ARCHITECTURAL REVIEW BOARD STAFF REPORT

Project #/Name	ARB-2025-10: 1906 – 1920 Avon St. Extended Initial Site Plan
Review Type	Initial Site Development Plan
Parcel Identification	09000000003300, 090000000033B0, 090000000033C0
Location	1906 – 1920 Avon St. Extended, north of Arden Dr. and across Avon St. from Dauphin Dr. (See Figure 1)
Zoned	Residential (R-10), Entrance Corridor (EC)
Owner/Applicant	Jeanette Smith/Shimp Engineering (Justin Shimp)
Magisterial District	Scottsville
Proposal	To construct a 21-unit residential subdivision with associated site improvements.
Context	The property is currently occupied by two houses, outbuildings, and mature trees. The Avon Park residential development is to the south, Spring Hill Village is across Avon St. to the east, Mill Creek is to the northwest, and Snow's contractors' yards and nursery are to the northeast.
Visibility	This development will be readily visible from the Entrance Corridor street.

ARB Meeting Date	May 19, 2025
Staff Contact	Margaret Maliszewski

Figure 3: Current proposed layout of the development.

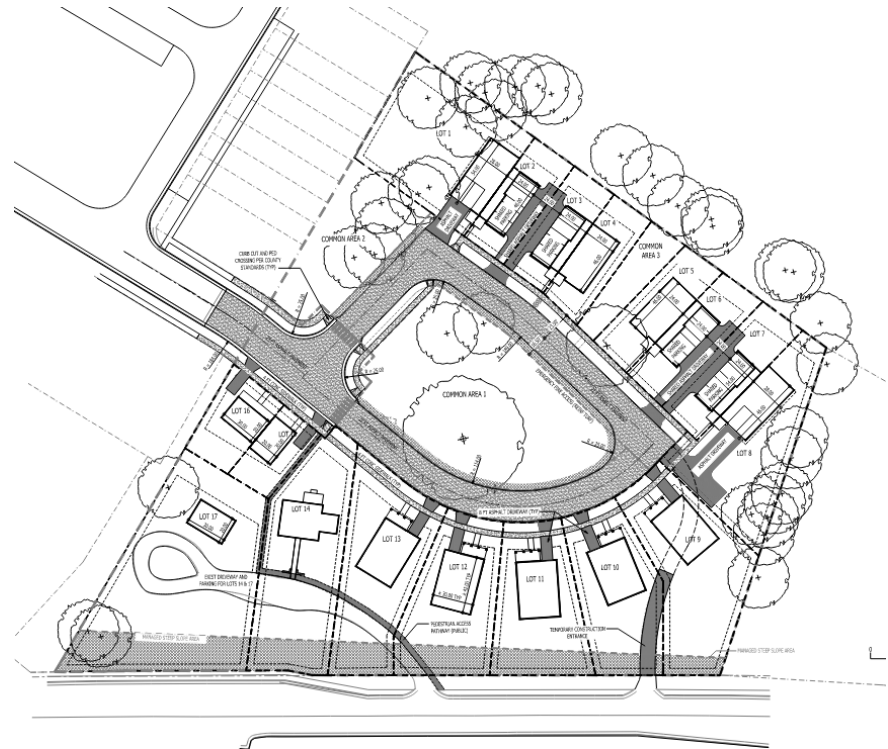
the existing environment of the corridor.	runs parallel to the street, close to the property line. A new sanitary line in a 20' easement is proposed along the EC frontage. Street trees are not typically allowed in this type of easement. The location of the easement would place the street trees 20' and more away from the EC.	along the EC. Provide a landscape plan showing how landscaping will be used to establish an appropriate appearance for the corridor.
8	Continuity within the Entrance Corridor should be obtained by planting different types of plant materials that share similar characteristics. Such common elements allow for more flexibility in the design of structures because common landscape features will help to harmonize the appearance of development as seen from the street upon which the Corridor is centered.		
32	Landscaping along the frontage of Entrance Corridor streets should include the following: a. Large shade trees should be planted parallel to the Entrance Corridor Street. Such trees should be at least 3½ inches caliper (measured 6 inches above the ground) and should be of a plant species common to the area. Such trees should be located at least every 35 feet on center. b. Flowering ornamental trees of a species common to the area should be interspersed among the trees required by the preceding paragraph. The ornamental trees need not alternate one for one with the large shade trees. They may be planted among the large shade trees in a less regular spacing pattern. c. In situations where appropriate, a three or four board fence or low stone wall, typical of the area, should align the frontage of the Entrance Corridor street. d. An area of sufficient width to accommodate the foregoing plantings and fencing should be reserved parallel to the Entrance Corridor street, and exclusive of road right-of-way and utility easements.	Bio-cells (small stormwater facilities) are proposed for each of the lots that have EC frontage, located in a private stormwater easement between the building site and the sanitary easement. This further hinders the ability to meet frontage planting requirements. The project engineer has indicated that some large trees can be planted in the bio-cells, but it isn't clear from the plan that a frontage planting consistent with EC Guidelines can be accomplished. Also, because the residential lots extend to the right-of-way on Avon, consistent maintenance of frontage landscaping is a potential issue.	Move the bio-cells and EC landscaping in common areas outside of individual lots.

Development pattern		
6	Site development should be sensitive to the existing natural landscape and should contribute to the creation of an organized development plan. This may be accomplished, to the extent practical, by preserving the trees and rolling terrain typical of the area; planting new trees along streets and pedestrian ways and choosing species that reflect native forest elements; insuring that any grading will blend into the surrounding topography thereby creating a continuous landscape; preserving, to the extent practical, existing significant river and stream valleys which may be located on the site and integrating these features into the design of surrounding development; and limiting the building mass and height to a scale that does not overpower the natural settings of the site, or the Entrance Corridor.	The site layout is generally organized and incorporates one of the existing residences, but the development is internally focused and mostly has its back to the EC. Buildings are not parallel to the EC. Vehicular and pedestrian connections are made to the Avon Park development to the south. A sidewalk is proposed from Avon into the development along the existing southern driveway. Many of the existing mature trees are proposed for removal. Many other trees shown on the plan are located off-site or on the northern property line. The placement of the sanitary line and related easement and the stormwater features prevent placement of street trees adjacent to the property line along Avon.	Revise the layout of the site to allow for required EC landscaping.

42	Areas designated for preservation in the final Certificate of Appropriateness should be clearly delineated and protected on the site prior to any grading activity on the site. This protection should remain in place until completion of the development of the site.		
43	Preservation areas should be protected from storage or movement of heavy equipment within this area.		
20	Surface runoff structures and detention ponds should be designed to fit into the natural topography to avoid the need for screening. When visible from the Entrance Corridor street, these features must be fully integrated into the landscape. They should not have the appearance of engineered features.	Seven bio-cells (small stormwater facilities) are located near the EC frontage, one for each lot that has frontage on Avon. The ground slopes up from the EC, and the bio-cells would be located at the edge of the managed steep slope area, above street level. The location of the bio-cells is a potential issue because it will likely impact plant choices and placement and is a maintenance concern on individual lots. The stormwater features would be better located in a common area. The location of stormwater features should allow for EC frontage landscaping.	Revise the plan to place utilities and easements in locations that allow for the required large shade trees and ornamental trees along the EC. Provide a landscape plan showing how landscaping will be used to establish an appropriate appearance for the corridor. Move the bio-cells and EC landscaping outside of individual lots and into a common area.

1. Revise the layout of the site to allow for required EC landscaping.
 2. Revise the plan to place utilities and easements in locations that allow for the required large shade trees and ornamental trees along the EC.

3. Move the bio-cells and EC landscaping outside of individual lots and into a common area.
- Regarding recommendations on the plan as it relates to the guidelines: None.
